APPEAL SUMMARY

Appeal ID: 27623	Project Address: 4047 N Williams Ave
Hearing Date: 3/30/22	Appellant Name: Mike Perso
Case No.: B-010	Appellant Phone: 503-841-5239
Appeal Type: Building	Plans Examiner/Inspector: David Bartley
Project Type: commercial	Stories: 4 Occupancy: R-2, S-1, M Construction Type: V-A
Building/Business Name:	Fire Sprinklers: Yes - throughout
Appeal Involves: Erection of a new structure	LUR or Permit Application No.: 21-060947-CO
Plan Submitted Option: pdf [File 1] [File 2] [File 3]	Proposed use: multifamily residential, retail

Appeal item 1

WILLIAMS 41

01 FLOOR PLAN LEVEL 1
1/4" = 1'-0"

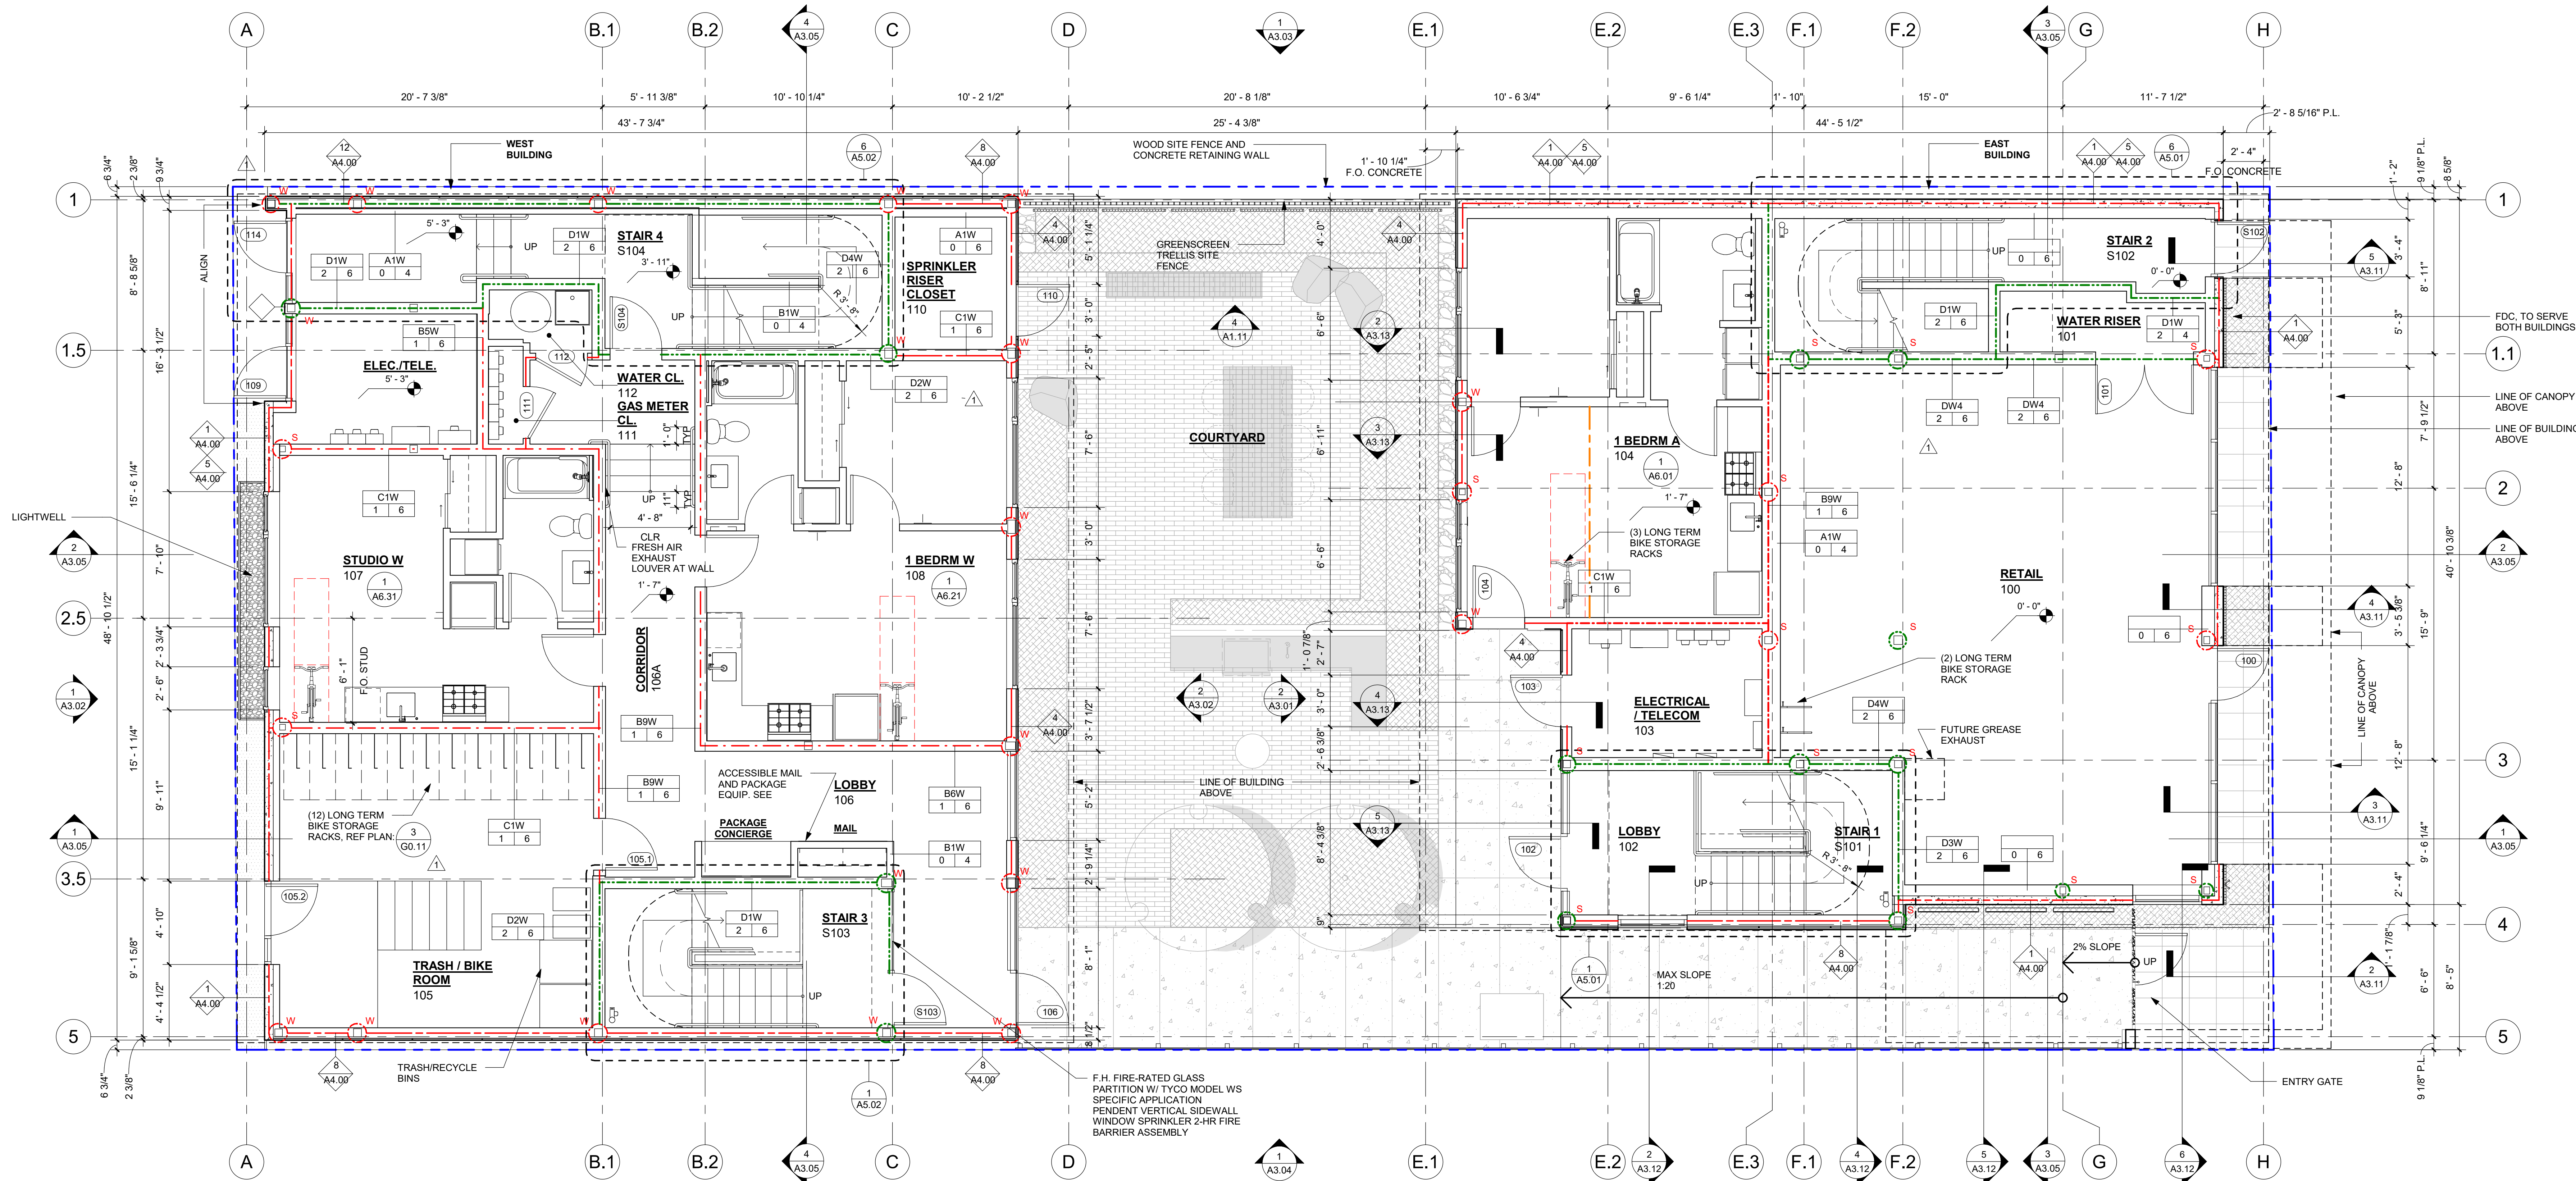
Code Section	1028.1
Requires	Exits shall discharge directly to the exterior of the building. The exit discharge shall be at grade or shall provide a direct path of egress travel to grade. The exit discharge shall not reenter a building.
Code Modification or Alternate Requested	This appeal requests that the path of egress travel be permitted to pass underneath the cantilevered building overhang after initially exiting the building and before discharging to a public way.
Proposed Design	<p>The proposed project consists of two, four story mixed-use buildings located on a site along N Williams Avenue. The two structures are separated by an internal courtyard and each building consists of three stories of residential apartments over ground floor lobby and residential units. Ground floor retail is located along the Williams Ave facade.</p> <p>Each building has two internal exit stairs, one that discharges directly to the building exterior at a public way (Stair 2 and Stair 4), and another that exits through the shared courtyard (Stair 1 and Stair 3). An egress court along the south lot line serves as the exit discharge component of the means of egress for both Stair 1 & Stair 3. It extends between the courtyard and the termination of the exit at the public way.</p> <p>The egress court is open to the sky with the exception of a portion adjacent to ground floor retail where the exit discharge passes under building overhang and, while enclosed by building on only two sides, is considered to be reentering the building. The egress path continues under building overhang for 22 feet until it terminates at the sidewalk on N Williams Ave. The area under the overhang is proposed to be a paved walkway with a small planting strip. The bottom of the soffit at the overhang is approximately 11'-10" above the walking surface.</p>

The fire resistance rated construction of the exterior wall along the egress court, including the portion of wall supporting the projection above is proposed to be increased to a 2-hour rating. Similarly a 2-hour rated horizontal assembly is proposed at the floor that overhangs the egress path. The entire building, including the path of exit discharge beneath building overhang in the courtyard, is fully sprinklered per NFPA 13. As an additional measure of protection, a moderate fire sprinkler hazard classification is proposed throughout the entire ground floor level and overhang. Openings at the Stair 1 landing and Retail space will be 45-minute rated openings.

The exit access and discharge to the right-of-way is readily visible and clearly identifiable from the lobby at both Stair 1 and Stair 3. Design elements such as glazing and paving, combined with the use of signage and lighting create a direct, clear, and unobstructed path from the termination of each exit stair to the discharge at the public way.

Exit discharge beneath building overhang: Granted provided Tyco sprinklers are installed in accordance with the manufacturer's specifications.
